TOLEDO-LUCAS COUNTY PLAN COMMISSIONS

REF: SUP-5001-18

SUBJECT: Special Use Permit for a used auto sales facility

SITE PLAN

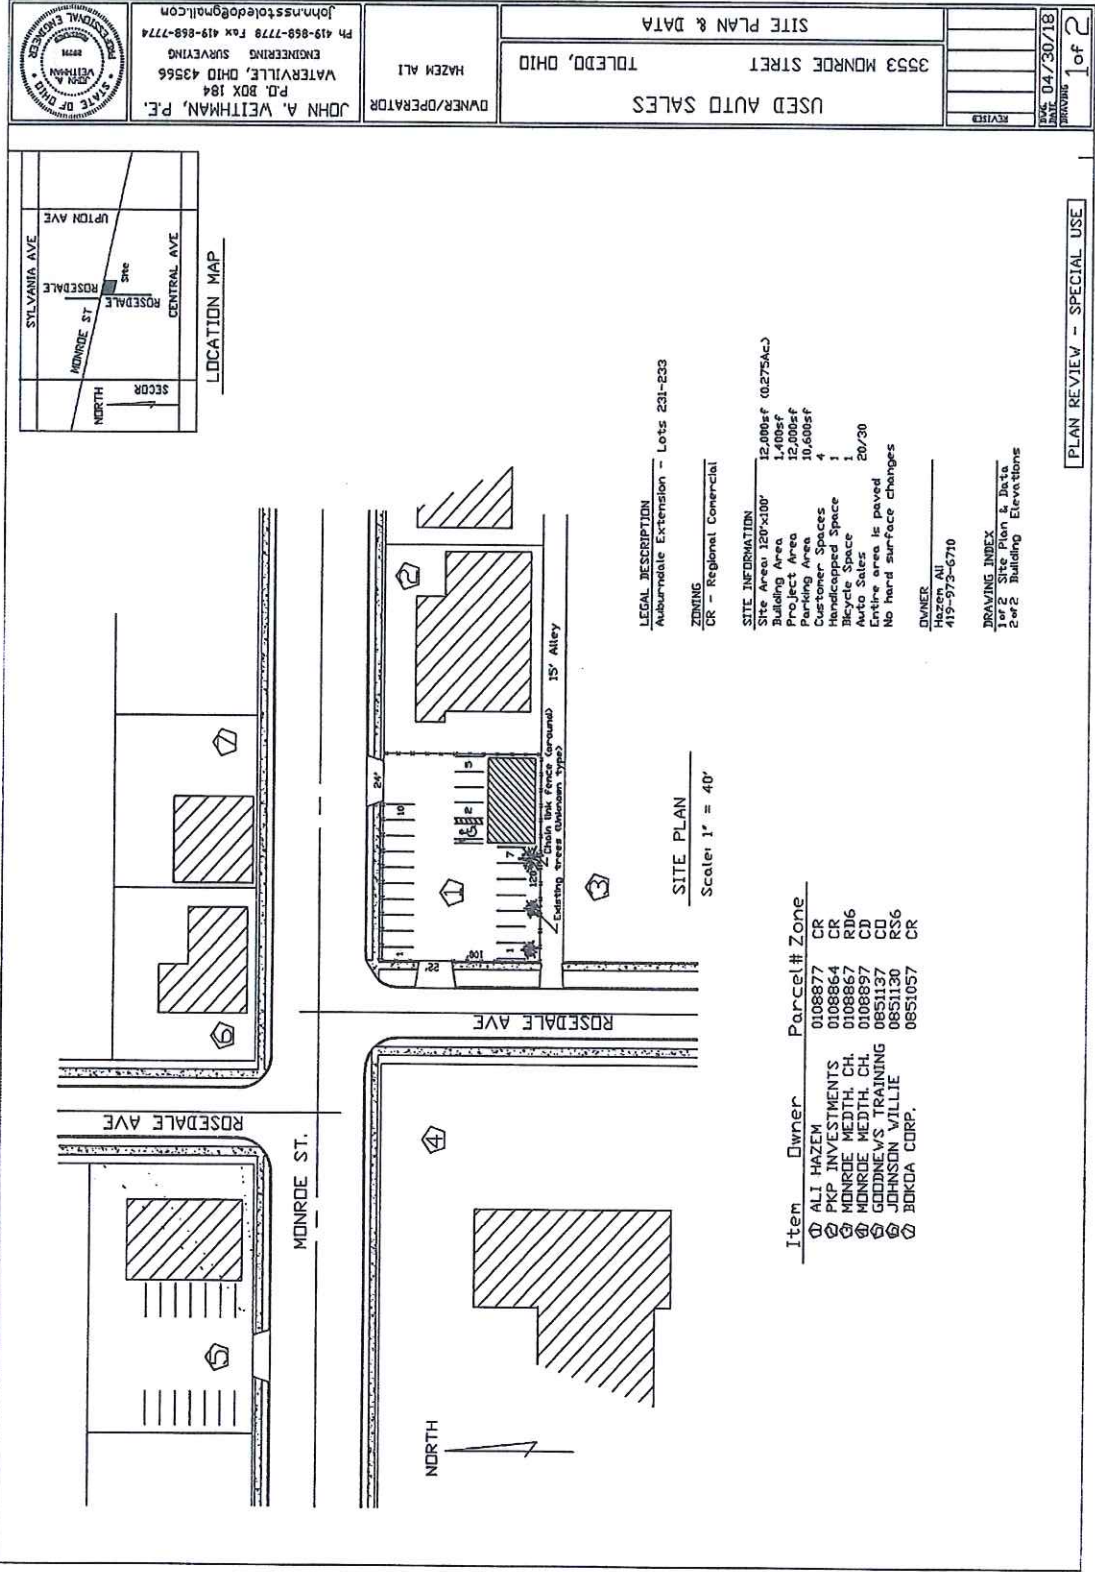
Elevated displays, lifts or metal structures used in conjunction with the display of motor vehicles shall be permitted only within those areas specifically designated upon the site plan and shall not be allowed in any required front yard. The site plan is not clearly dimensioned and, if the Special Use Permit is approved, will require revision showing compliance for the approval of the Planning Director. Additionally, a fifty (50') foot separation measured along the street frontage between any open display sales lot and a Residential district boundary line shall be maintained. This separation shall apply to both sides of a street and to intersecting streets on corner lots.

Pursuant to TMC§1107.0304 – Parking, Loading, and Access: Schedule A, a used auto sales/rental facility is required to have one (1) parking space per every 5,000 square feet of open sales area, plus one (1) parking space per every 500 square feet of enclosed sales area, plus one and one half (1.5) per every service bay. Calculations using the existing building's square footage as enclosed sales area conclude that a total of five (5) customer spaces are required for the site. The site plan depicts a total of eleven (11) customer parking spaces. The site plan depicts a total of twenty-four (24) spaces however it is unclear which are designated for customer/employee parking and auto sales display.

Site plans for used automobile and recreational vehicle sales shall delineate, with dimensions, parking areas and drive aisles for the outdoor display area and customer/employee parking area. Required customer/employee parking may not be used for used vehicle inventory (TMC§1104.0308). Used vehicle inventory shall only be displayed, parked or located within parking spaces approved and defined on the site plan. All areas of the site used for customer parking must be paved per TMC§1107.1906 and adequate storm drainage shall be provided. Parking on grass or gravel is not permitted. Loading and/or unloading is prohibited in the public right-of-way. This is listed as a condition of approval.

13. To ensure compliance with Toledo Municipal Code (TMC) requirements for parking, loading and access, the site plan must include drive aisle, parking stall and access drive dimensions.
14. Drives must 25' to maintain 2-way traffic.

15. Dumpster location(s) shall be clearly defined, have a concrete pad and be surrounded by a solid wooden fence or a masonry screen enclosure with landscaping and shall not be located in any required setbacks. **(Not depicted on site plan. A revised site plan shall be submitted showing compliance).**
16. Dumpsters may not be located in any required setback or landscape buffers and shall be located as far away from residential areas as possible (TMC§1108.0203(G)(5)). **(Not depicted on site plan. A revised site plan shall be submitted showing compliance).**
17. Dumpsters may not be located in the public right-of-way as stated in TMC§1361.10(b)(10) of the Building Code. **(Not depicted on site plan. A revised site plan shall be submitted showing compliance).**

19. All vehicles on display must be parked in striped parking spaces that shall be designated on an approved site plan. Vehicle parking that deviates from the approved site plan shall not be permitted. Customer parking and display parking must be clearly differentiated on site plan. **(Not depicted on site plan. A revised site plan shall be submitted showing compliance).**

23. A fifty (50') foot separation measured along the street frontage between any open display sales lot and a Residential district boundary line shall be maintained. This separation shall apply to both sides of a street and to intersecting streets on corner lots. **(Acceptable as depicted on the site plan).**

- a. Greenbelts are required along all street frontages. Greenbelt frontage landscaping shall be adhere to TMC§1108.0300 – *Urban Commercial Landscape Standards*. Calculations conclude that four (4) tree pits are required along Monroe Street. Tree pits that incorporate storm water management are encouraged. Furthermore, four (4) trees are required along Rosedale Avenue. Existing trees may be eligible for credits as outlined in TMC§1108.0407(B)(d). **(Not acceptable as depicted on the site plan. A landscape plan shall be submitted showing compliance);**

- b. Perimeter landscaping must consist of one of the following, located between the parking lot and the property line: landscaped area at least five (5') feet wide, exclusive of easements, sidewalks, or rights-of-way, planted with at least one (1) shrub for every three (3') to five (5) feet of property line, as determined by growth characteristics; 3 ½ feet high metal tuber or solid bar fence, with at least one (1) shrub for every three (3') to five (5') feet of property line planted on the outside of the fence; or solid 3 ½ foot high brick or stone wall. Existing trees are accredited as outlined in TMC§1108.0407(B)(d). **(Not acceptable as depicted on the site plan);**

- c. A Type A landscape screen and buffer shall be provided along the rear of property that abuts RD6 Duplex Residential zoning. **(Fencing material not acceptable as depicted on the site plan and shall be of a decorative style –aluminum tube or wrought iron);**

- d. A perimeter landscape buffer shall be provided abutting the parking area and to visually screen all off-street loading facilities from view of Residential districts and public right-of-way. A solid evergreen hedge planting with a minimum height of eighteen (18") inches (when installed so as to achieve full screening at maturity) shall be provided. **(Not acceptable as depicted on the site plan);**

- e. All existing trees on the site with a caliper of four (4") inches or more must be mapped prior to site planning and should be incorporated into the landscape plan to the maximum practical extent. **(Acceptable as depicted on the site plan);**

- i. The location, number, height, diameter and species of any materials to be planted and maintained, as well as the location and number of any existing trees to be retained, trees, shrubs, and landscape materials shall meet the standards included in TMC§1108.0400 Landscape Materials Standards and the State of Ohio Department of Agriculture's invasive plant list (**Not depicted on site plan**);
